(UNCLASSIFIED)
REPORT OF FRAGILITY TEST
ON
SMB-1-25/H4BC
WITH STANDARD CAST ADAPTER
FOR
LIMITORQUE CORPORATION
KING OF PRUSSIA, PENNSYLVANIA

Shearon Harris Nuclear Power Plant
Draft SER Open Item No. 354
NRC Question 210.52

Shearon Harris Nuclear Power Plant
Draft SER Open Item No. 354
NRC Question 210.55

1 1/4" WATER SPHERE VALVE NUCLEAR CL3
150 ANSI FLANGED VGC-8 MANUAL GEAR
ACTUATOR

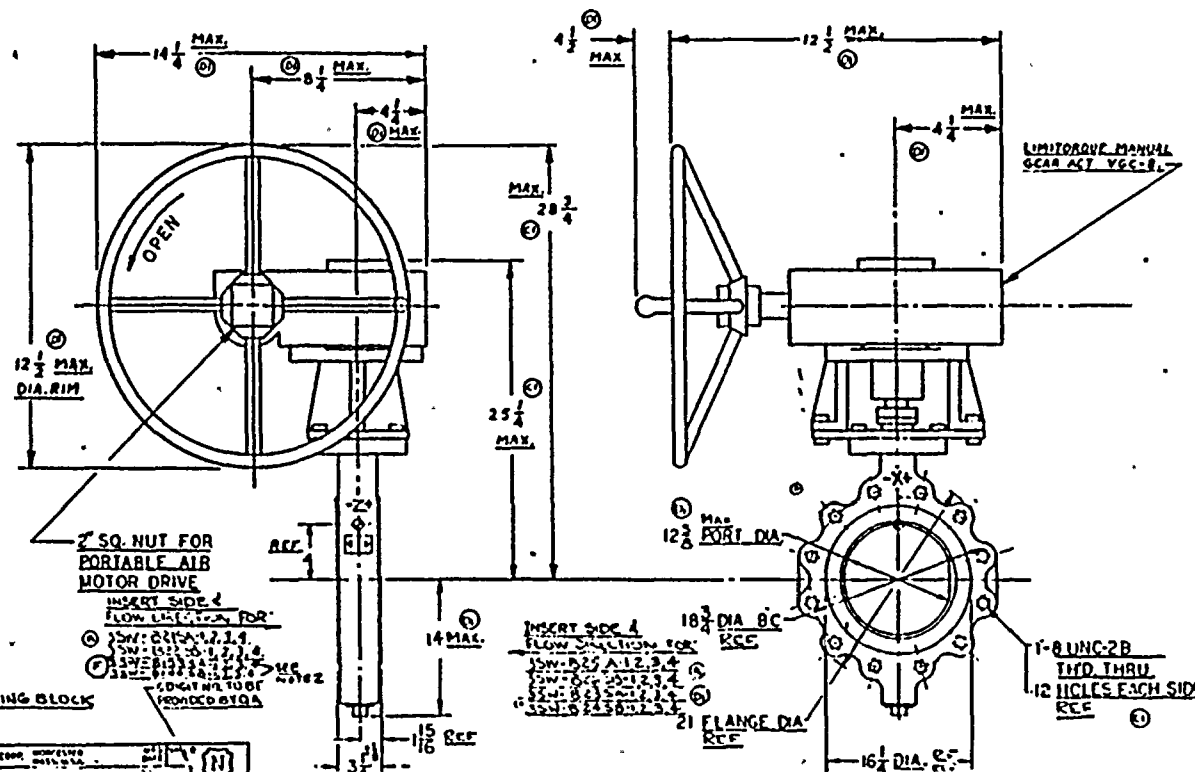
The procedure in Report JHA-77-99 dated 8/2/78 is incomprehensible without drawings of the valves. Furnish drawings for the valve identification on Butterfly Valve Data Sheet 5 of 48, P. O. No. NY-435082. The drawings should be in sufficient detail so that we can check the dimensions used in the calculations in the Report for this specific valve.

Please find attached copies of valve drawings on Valve Data Sheet 5 of 48. These are the drawings furnished by Jamesbury to Fbasco. Jamesbury do not release detail (shop) drawings of their product other than to an independent engineering consultant for analysis work. However, if a specific dimension or group can be identified for a given part we can more easily comply with your request.

DO NOT SCALE DRAWING	DATE
BY	A. L. EMBURY	7-2-62	
FOR	WAFER SPURGE VALVE FC-872TA-1X-MOD C	12	FILE
	150° ANSI	100	
DESIGNED BY	EMBURY	D R-28405-17

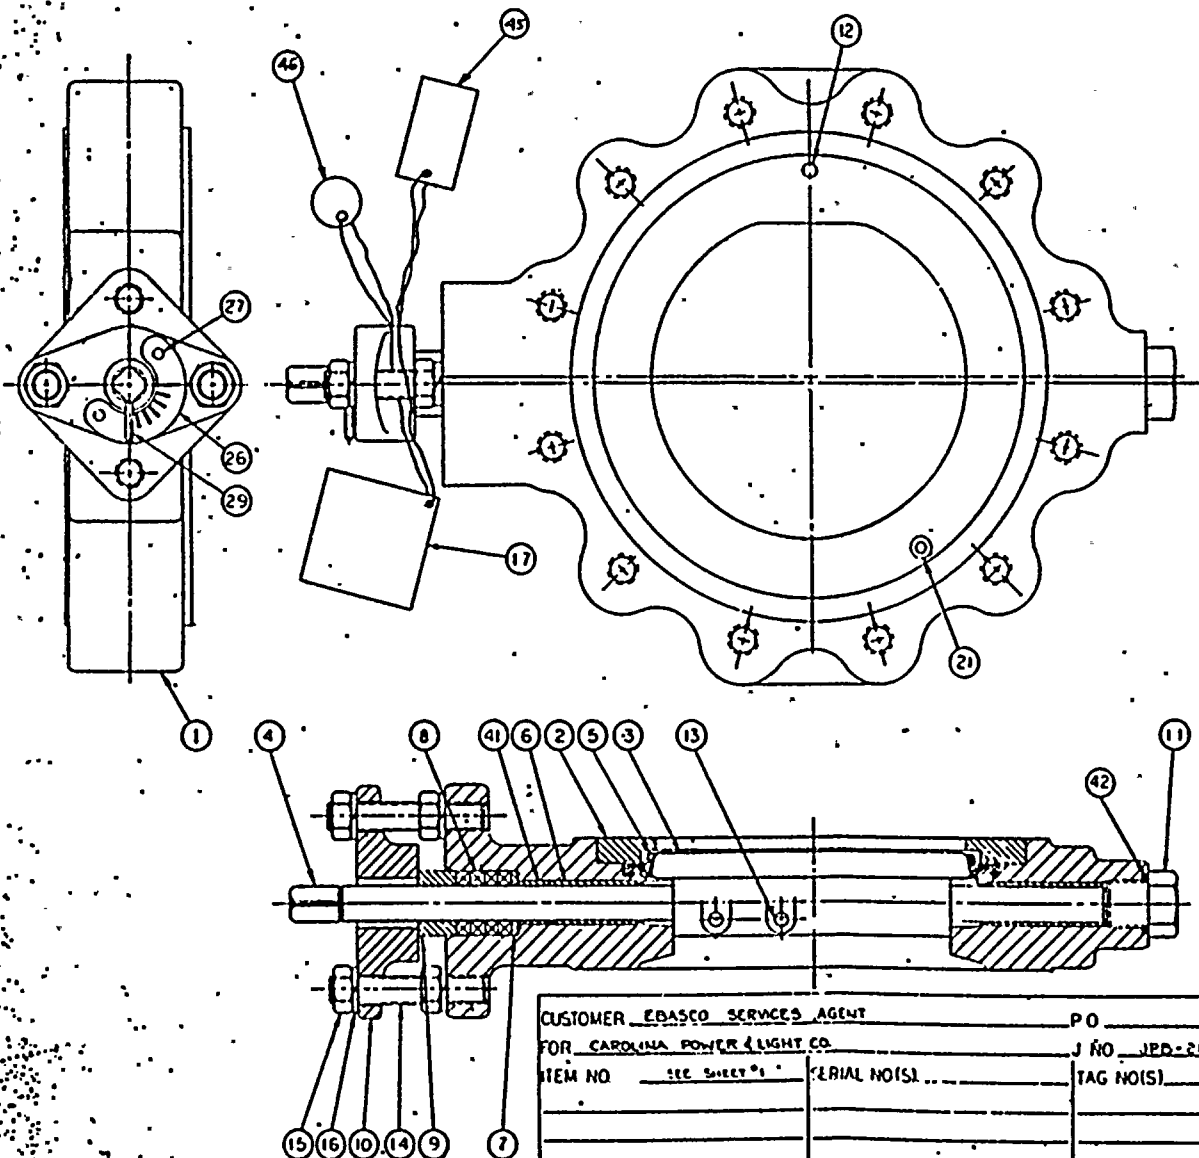
- (a) Where did the 95000 (psi?) yield strength for "Type 316 ST. STL." come from?
- (b) Material to A-564 Type 630 is furnished with minimum specified yield strengths ranging from 75 ksi to 170 ksi, depending upon the hardening and/or aging treatment. Where does the Specification CAR-SH-M-44, Rev. 13 address this treatment so that the Report can use a yield strength of 125 ksi?

- (c) Page 93 of the Report shows calculated shaft membrane plus bending stresses of up to 74000 psi. If failure of the shaft can lead to failure of the pressure boundary and if the calculated stresses are mainly due to pressure, the calculated stresses are deemed to be excessive. What are the calculated shaft stresses for the valve identified in Butterfly Valve Data Sheet 5 of 48, P. O. No. NY-435082 due to the Design Pressure of 225 psig? What are the allowable stresses for design conditions and where are they identified in the Specification?

- (a) The 316SS referenced is per 00-S-763 condition B which has a yield of 95000 psi. The shaft material was later changed to ASTM A-564 type 630 H1025. (See approved outline/assembly drawing). The yield is higher for A-564 than 00-S-763.

- (b) The Specification does not specify detail requirements of all materials used to fabricate the valves. The Seller had selected A-564 Type 630 H1025 as the shaft material as indicated in the valve assembly drawings (sample attached). Therefore, the use of 125 ksi yield strength is appropriate, per ASME material specification (A-564 type 630 H1025-Yield stress = 145,000 psi).

- (c) The 14" valve with SMB-000/2HIBC Actuator was deleted from the contract and is not applicable. However, the stress shown is for a design pressure of 225 psig and qualifies shaft for the item on data sheet 5 of 48 with gear actuator. The valve shaft is not a pressure retaining part by ASME Section III Code and the actual allowable stress is per the AISC manual of steel construction or $0.9 \times S_y$ of 145000 = 130500 psi, hence a 76% safety factor on allowable.
